**S20 ALAMEDA COUNTY SCIENTIFIC REVIEW COMMITTEE REPLIES TO THE
PARTIES' RESPONSES TO ITS QUERIES AND TO COMMENTS FROM THE
CALIFORNIA OFFICE OF THE ATTORNEY GENERAL**

3 April 2007

S15_ ESTIMATED EFFECTS OF PROPOSED MEASURES TO BE APPLIED TO 2,500 WIND TURBINES IN THE APWRA FATALITY MONITORING PLAN

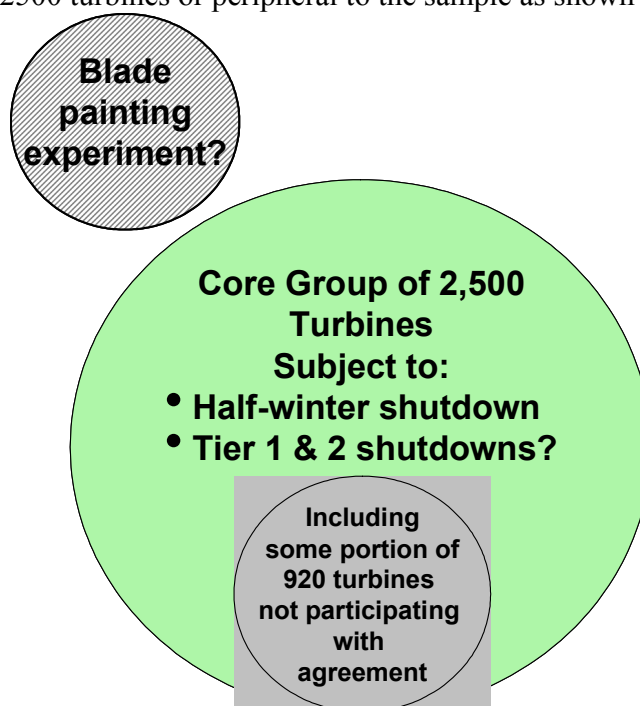
The following diagram summarizes the extent of the mitigation measures likely to be implemented among the 2500 wind turbines to be monitored to estimate the effectiveness of the mortality reduction measures. The blade painting experiment remains uncertain due to a patent issue, although a smaller experiment might be implemented among some of the 920 wind turbines owned by a company not participating with the settlement. If the larger blade painting study is implemented, the SRC has yet to agree whether it will be implemented within the monitoring sample of 2500 turbines or peripheral to the sample as shown in the diagram below.

If additional mitigation measures are implemented, the SRC has yet to decide how the affected turbines will be incorporated into the monitoring program, or whether they will be treated peripherally to the monitoring sample. Electric distribution pole retrofits cannot be considered because they have no bearing on turbine collision-caused mortality. Ceasing rodent control also cannot be considered because the SRC does not know whether landowners continued with rodent control, and the SRC will have no power over the landowners' decisions on this matter. According to recent information from the Parties to the settlement, the Companies will not remove artificial rock piles or derelict turbines or derelict towers. It does not appear additional mortality reduction measures will be implemented until 2010.
